From: Marco Bartolini [REDACTED]
Sent: 18 January 2018 16:57
To: Bernie Harverson
Cc: Richard Martin; Juan Baeza; Cllr. Norman Dingemans; Joe Russell-Wells; Mark Warwick
Subject: Re: Tree Protection Measures at Oakview (formerly Red Cottage); Arun District Council Planning Application WA/78/17/DOC

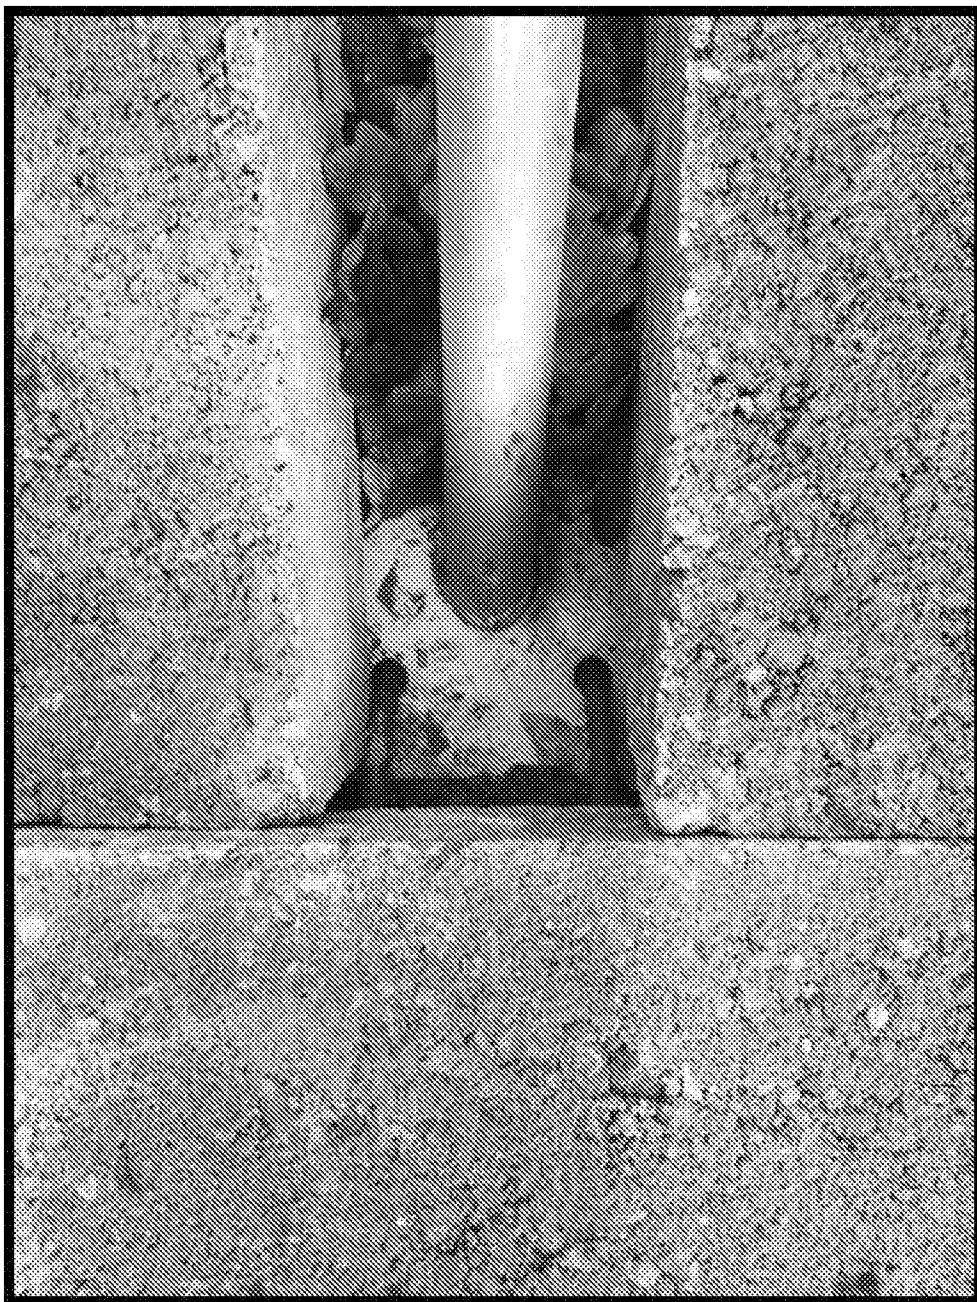
- Not in the correct locations as per your AMS report and Tree Protection Plan.
- Not being 'fit for purpose' as regards compliance with BS5837 as there are no back stays and ground pins.

I note that you have as part of this email submitted photographs to show that the protective fencing has been moved out to the correct locations as per your AMS report and TP Plan and from what I can see there appears to be backstays secured with ground blocks but I cannot clearly see from the photographs any ground pins securing the whole affair into the ground – could you please submit photo's to show this?

In accordance with your request to confirm that the rear legs of the Tree Protection Barriers are secured, I have attached a further photograph zoom image of the base-plate. Unfortunately you were unable to see this on a previous photograph and the securing pin has been driven in to ground level.

As an aside, and to reassure you, the gate you see in the above photograph is not actually a working gate, more a false gate panel to 'look' like a gate. Therefore NO pedestrian access can be made through this assumed entrance way. Hence no requirement for ground protection at this time (although I do know that this was a working garden and mini-orchard so has experienced lots of compaction already).
